**CONSTRUCTION OF THE BUILDING OF THE RESEARCH AND
DEVELOPMENT INSTITUTE FOR INFORMATION TECHNOLOGY OF
BIOSYSTEMS (BIOSENSE) IN NOVI SAD, SERBIA
(PROCUREMENT NO. IOP/43-2020/RD)**

Clarification no. 11

Issued on July 2, 2020

Figure 1

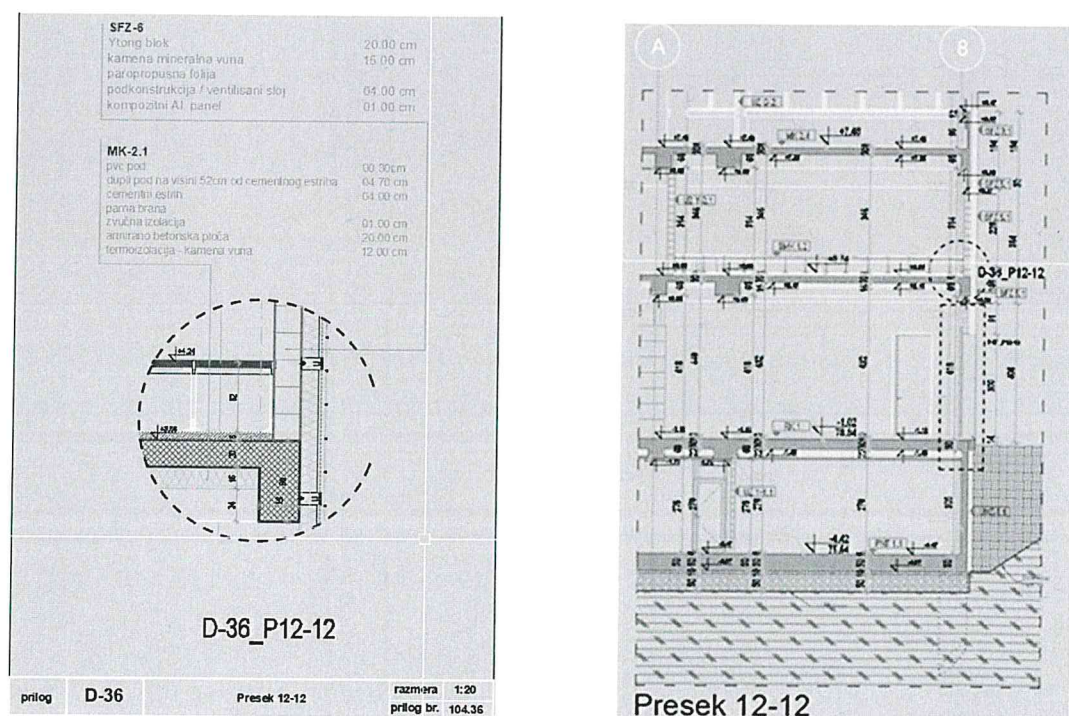
Question 4: Please clarify what is finishing layer over the raised floor, since in the detail SMK 1.2 is shown that there is nothing over it. Also, clarify if this finishing layer is in the scope of works of the General Contractor.

Answer 4: The detail is given within the cross-section No. 12 (figure 1) - special antistatic floor that are installed over the substructure in the raster 60X60cm. It is double layered floor, finishing layer is from PVC, and beneath are stiff plates.
